VARIATION 307 TO THE TERRITORY PLAN

Griffith, Section 42, Block 15

GOVERNMENT RESPONSE TO THE
STANDING COMMITTEE ON PLANNING, PUBLIC WORKS AND
TERRITORY AND MUNICIPAL SERVICES - REPORT 12
FEBRUARY 2012

VARIATION 307

Figure 2: location of existing informal paths to be formalised.

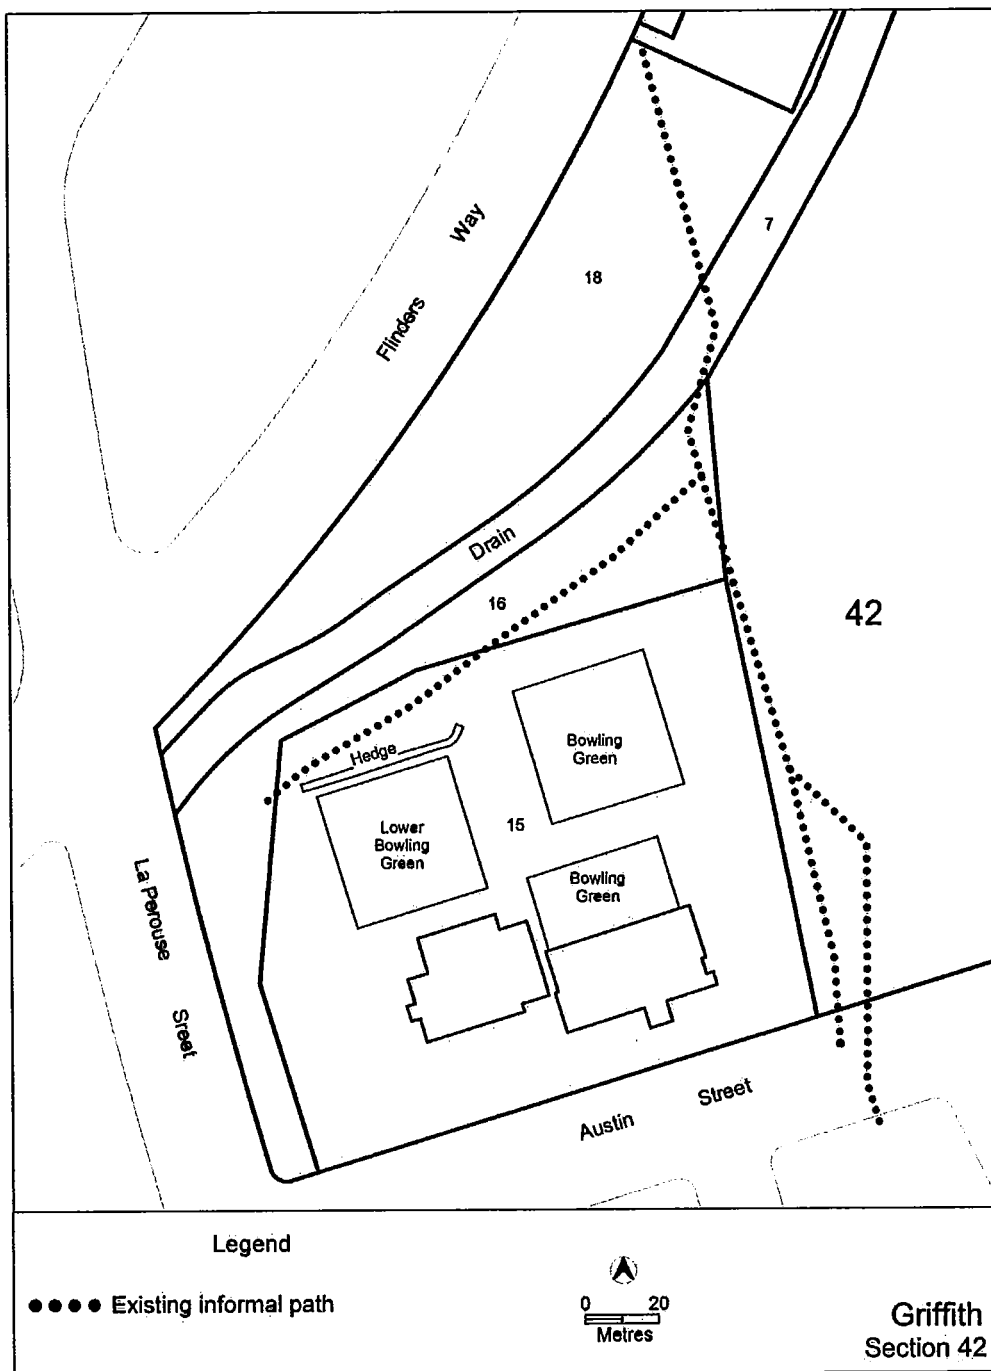
(b) a new bicycle path be constructed in this area of public realm to make the area more accessible to the general public and provide an alternative transport route to Manuka and beyond to Telopea Park;

(c) the well worn track which starts in Austin Street near Wells Gardens and proceeds towards Manuka be landscaped and improved to make the area more accessible to the general public. This should include a cycle path or wider paved area for the enjoyment of cyclists and pedestrians and some seating that allows people to sit and enjoy the surrounding area;

(d) appropriate up to date flood warning signs be placed along pathways and access points to Section 42 Griffith;

Rules	Criteria
7.1 off site works	
R5 Shared paths are constructed within block 16 and the part of block 15 subject to the public access easement in Rule R2, along the northern and eastern boundaries of block 15 as identified on Figure 2 and are endorsed by the Territory agency responsible for asset acceptance.	This is a mandatory requirement. There is no applicable criterion.
R6 Flood signage is erected along pathways and access points to Section 42 Griffith and is endorsed by the Territory agency responsible for asset acceptance.	This is a mandatory requirement. There is no applicable criterion.

Figure 1 Areas with no development or encroachments

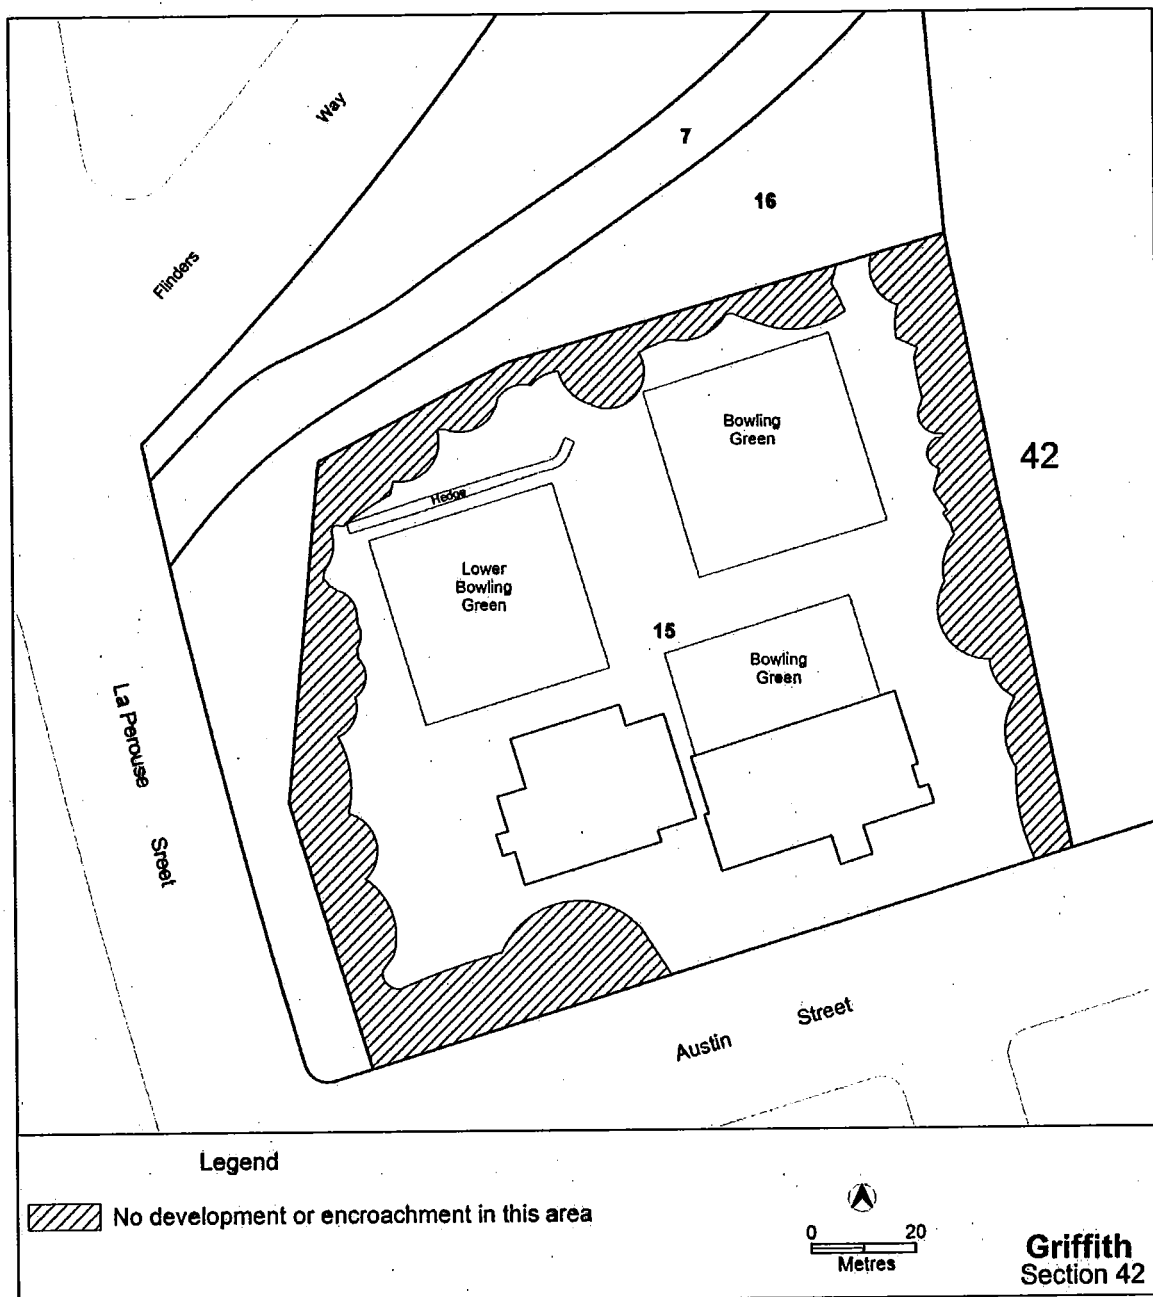
(e) any development or associated construction works not encroach on land lying under existing stands of trees on the perimeter of Block 15 and so by definition their respective root systems. At a minimum all perimeter trees are to be retained and all regulated trees are to be retained;

Rules	Criteria
6.1 Trees	
R4 Building and construction works do not encroach on land within the drip zone plus 2.0m of the existing stands of trees on the perimeter of Block 15 as identified on Figure 1.	C4 The health of existing trees on the perimeter of block 15 is maintained. Compliance with this criterion is supported by an assessment by a suitably qualified arborist and to the satisfaction of the Conservator of Flora and Fauna.
